HYDRAULICS DIVISION

Technical Note

DATE: June 1980 **REPORT NO:** 80-23

TITLE: Technical Review of Proposal to construct Six Artificial Islands in the Mackenzie River at Norman Wells, N.W.T.

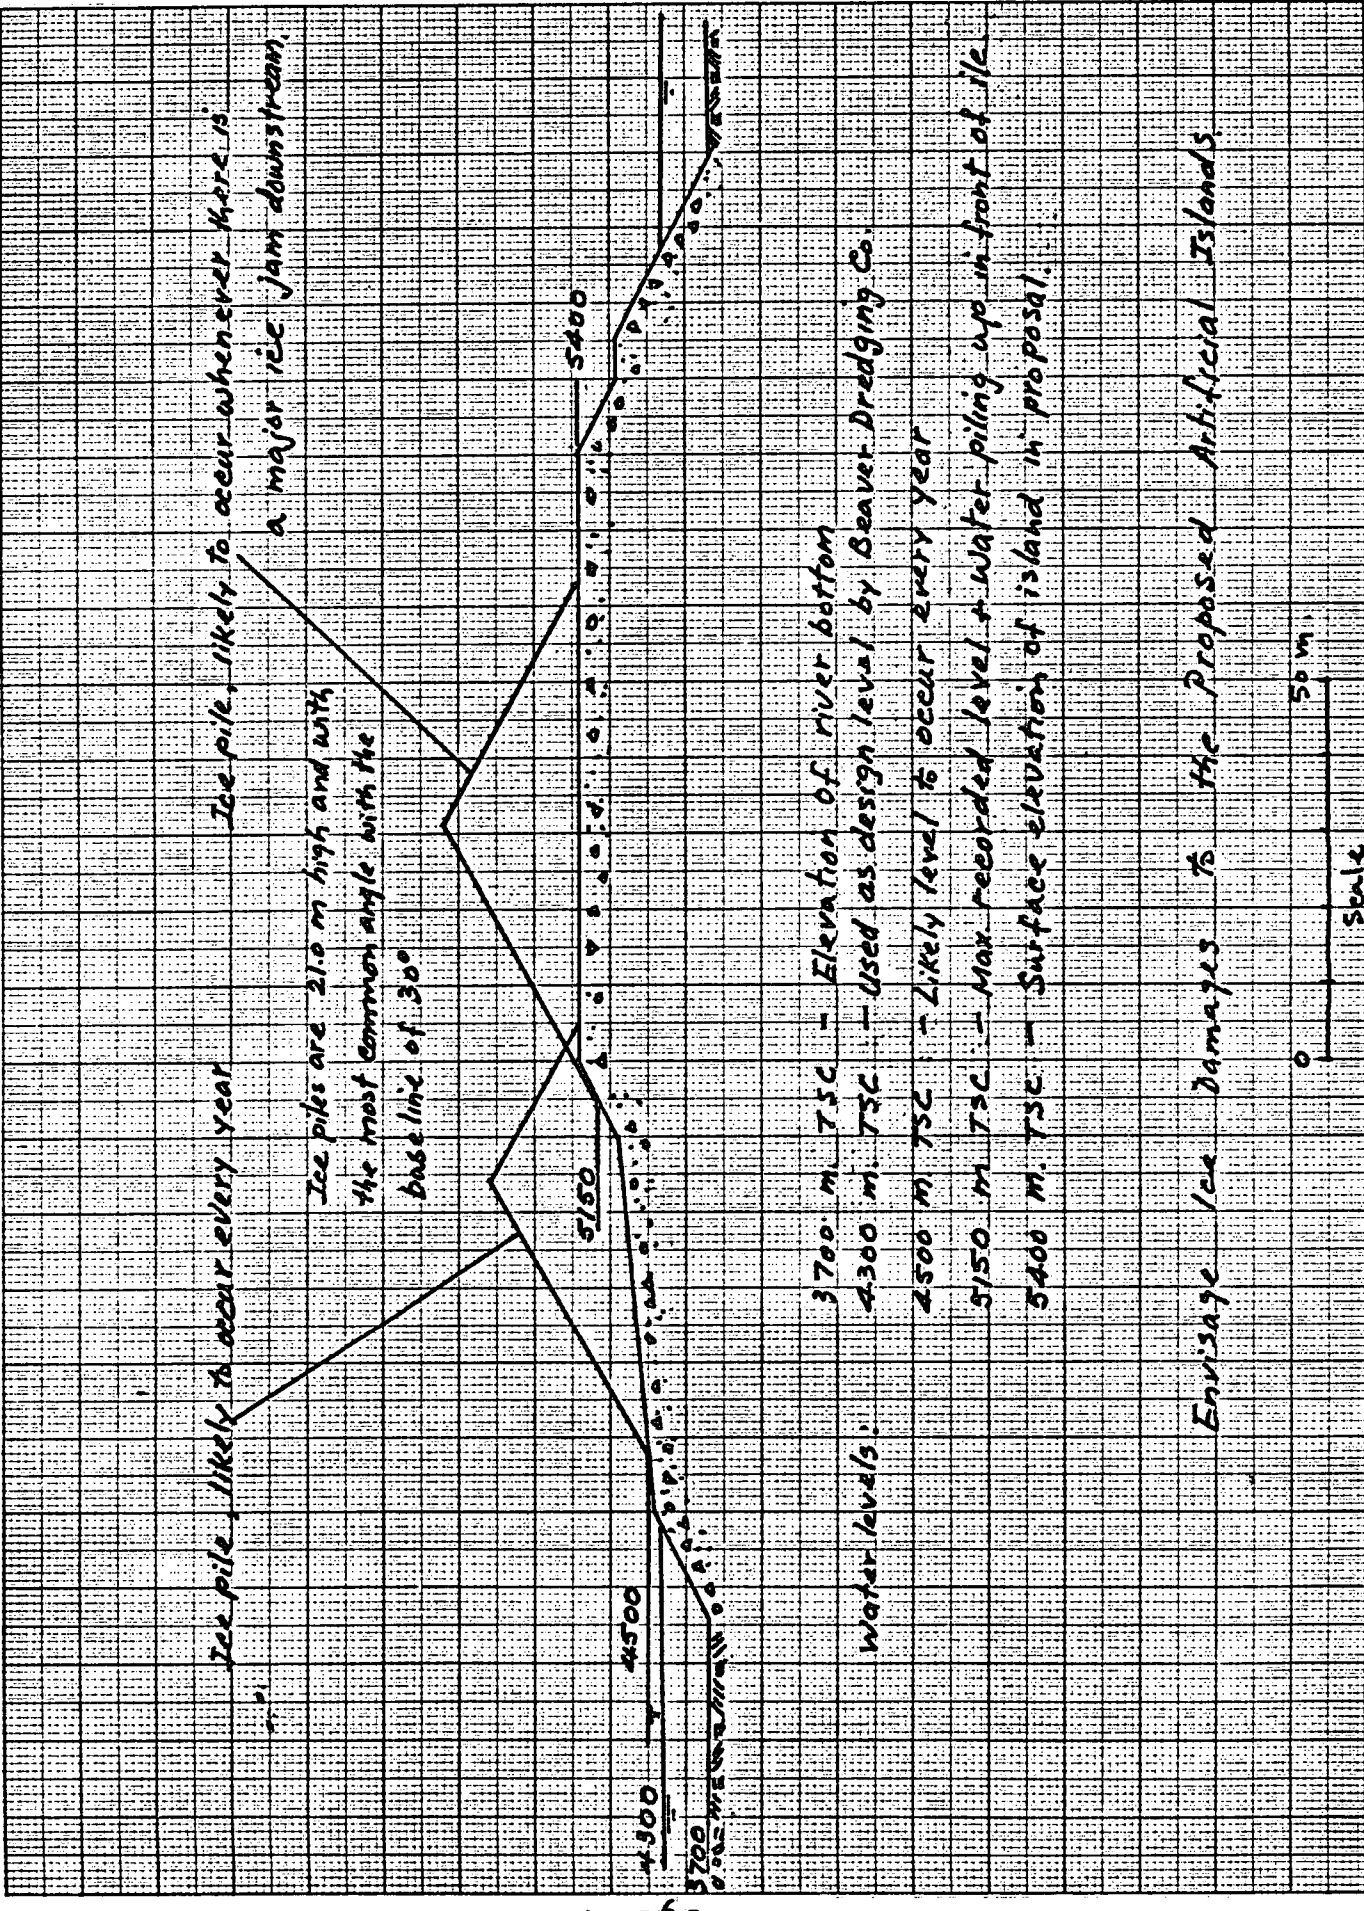
In the Beaver Dredging Company's report, ice piles are assumed to be so positioned that their peak is 10 m inshore to the point of changing slope (see Fig. 10 of report). There is no basis for such an assumption. Field study on Lake Simcoe (Tsang, 1974) showed that the toe of the piles was very close to the point of ice piling initiation. The figure on the following page shows ice piles so positioned on the island. The lower pile is plotted for the case of:

$$\beta = 30^\circ, \quad H = 21.0 \text{ m} \text{ and water level} = 4500 \text{ TSC}$$

a case that can be expected to occur every year, and the higher pile is plotted for the case of:

$$\beta = 30^\circ, \quad H = 21.0 \text{ m} \text{ and water level} = 5150 \text{ TSC}$$

a case that will happen whenever there is a significant ice jam downstream from Norman Wells. It is seen from the figure that the proposed artificial island will be threatened every year by ice piling. Should there be a major ice jam downstream, the whole island could very easily be completely buried under the ice pile.

Fig. A. Slope-Discharge Relation for Braiding or Meandering in Sand Bed Streams (after Lane (1957))

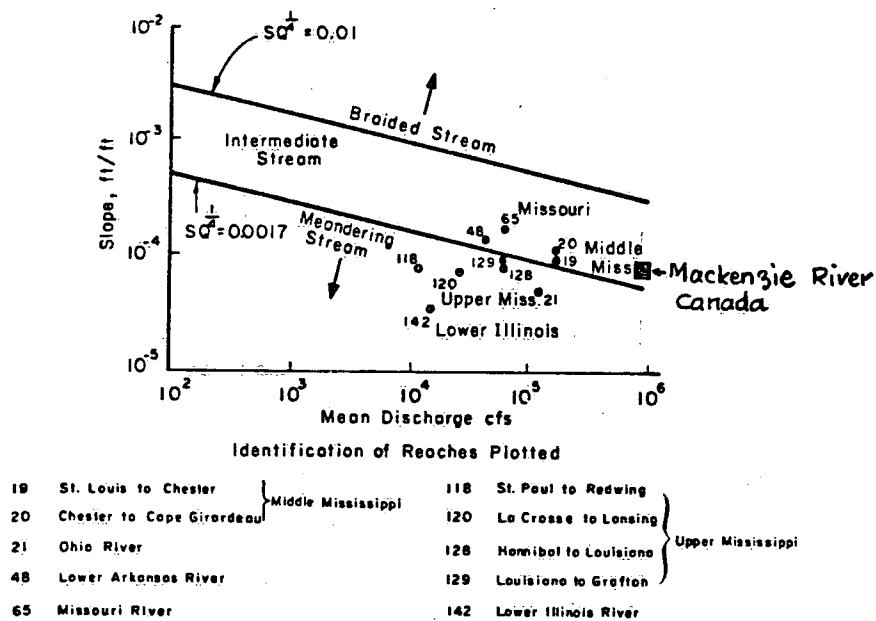
By plotting the slope of the Mackenzie River against the dominant or channel forming discharge of $28\,300\text{ m}^3/\text{s}$, the report classifies the Mackenzie River as the one belonging to stability category 2 (Neill's terminology), i.e. a channel with variable width and some mid-channel bars. When the same slope and discharge values are plotted in a diagram proposed by Lane (1957)* as shown in the attached figure (Fig. A), the Mackenzie River falls under the category of intermediate stream, i.e. a stream pattern lying between a more stable meandering pattern and a highly unpredictable braided pattern. River morphological studies carried out by Lane (1957), Leopold and Wolman (1957)** suggest that in a stream of intermediate pattern, any small increase in the overall channel slope could initiate a tendency toward a braided pattern characterized by its rapid changes in alignment and unpredictable behaviour. Therefore, it appears that the impact of the proposed artificial islands in the long run could be even more severe than that suggested in the report which suggested that the morphological impact of the artificial islands in the form of modification of cross sections and bed-level changes would be limited only to a 4 km stretch of the Mackenzie River adjacent to Norman Wells.

Fig. B. Bed-Form Steepness as a Function of Excess Transport Capacity
(after M. S. Yalin, 1972)

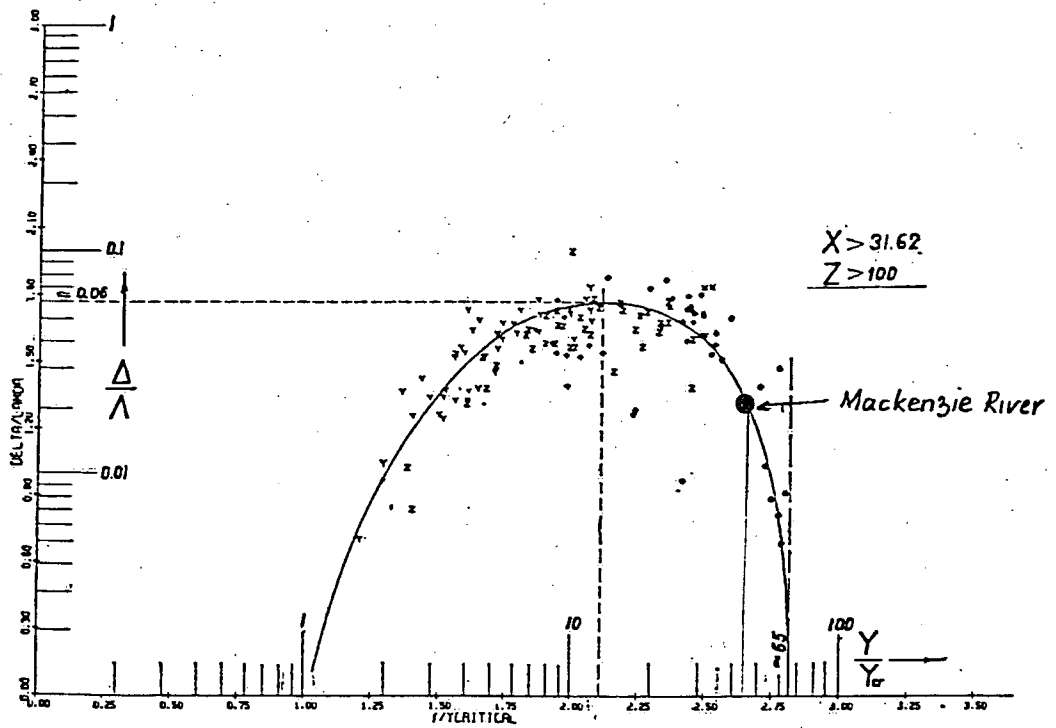
With respect to bed forms, the report under the section 4.1 on channel roughness states that the development of the bed form is not extreme. This statement is only partially true. Indeed, if one computes the ratio of the Shield's parameter to the critical Shield's parameter, one gets a value of 42.5. This high value suggests, according to Yalin's graph shown in Fig. B, that the bed-form steepness is on the descending side of the graph implying that the river is in the stage of washing out of the bed forms with high sediment transport rate in the vicinity of the bed and in the bulk of the flow.
